Form 3160-5
(June 2019)

SUNDRY NOTICES AND REPORTS ON WELLS
Do not use this form for proposals to drill or to re-enter an abandoned well. Use Form 3160-3 (APD) for such proposals.

Betty 5 Fed Com 581H (FKA Getty 5 Fed Com 746H) API #: 30-025-52101

EOG respectfully requests an amendment to our approved APD for this well to reflect the following changes:

Salt Section Annular Clearance Variance Request

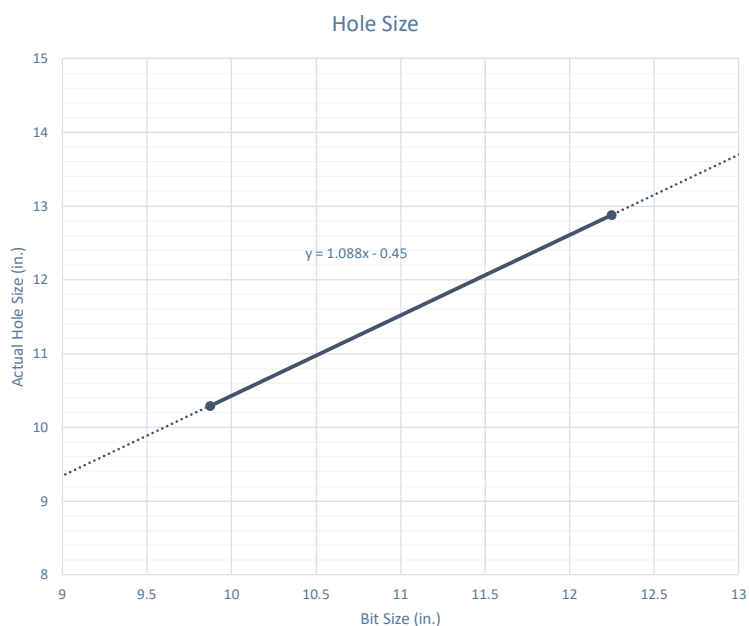
EOG request permission to allow deviation from the 0.422" annulus clearance requirement for the intermediate (salt) section from Onshore Order #2 under the following conditions:

- The variance is not applicable within the Potash Boundaries or Capitan Reef areas.
- Operator takes responsibility to get casing to set point in the event that the clearance causes stuck pipe issues

Design A

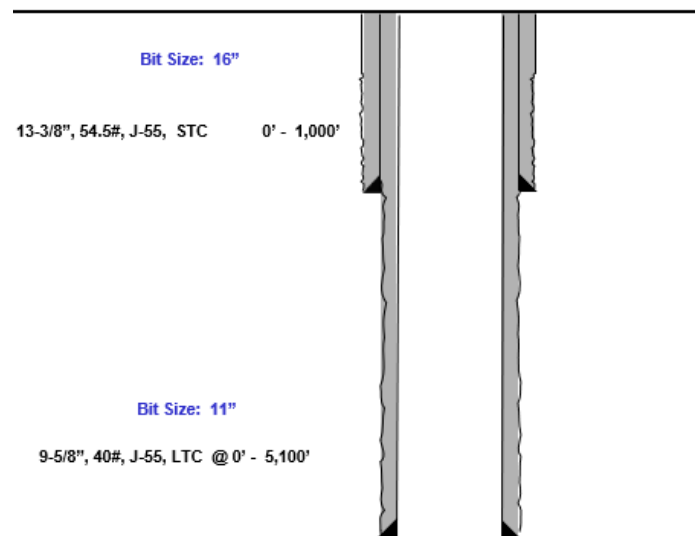
Proposed 11" Hole with 9.625" 40# J55/HCK55 LTC Casing

- 11" Bit + 0.52" Average hole enlargement = 11.52" Hole Size
 - 0.9475" Clearance to casing OD

Design B

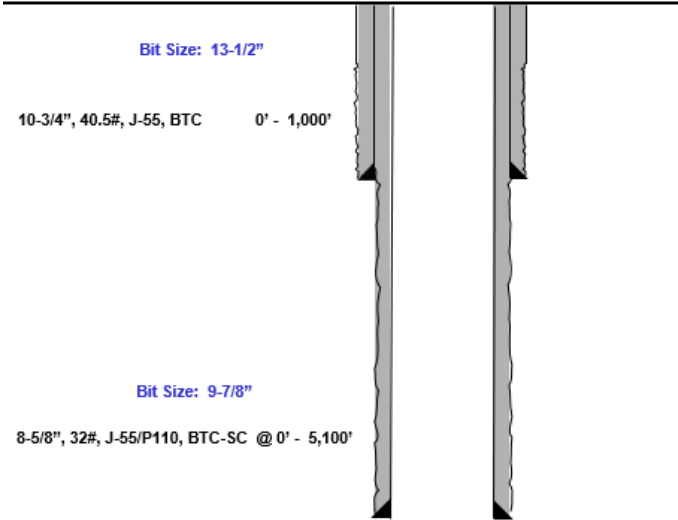
Proposed 9.875" Hole with 8.625" 32# J55/P110 BTC-SC Casing

- 9.875" Bit + 0.42" Average hole enlargement = 10.295" Hole Size
 - 0.835" Clearance to casing OD
 - = $\frac{10.295 - 8.625}{2}$
 - 0.585" Clearance to coupling OD
 - = $\frac{10.295 - 9.125}{2}$
- Previous Shoe – 10.75" 40.5# J55 STC
 - 0.4625" Clearance to coupling OD (~1,200' overlap)
 - = $\frac{10.05 - 9.125}{2}$
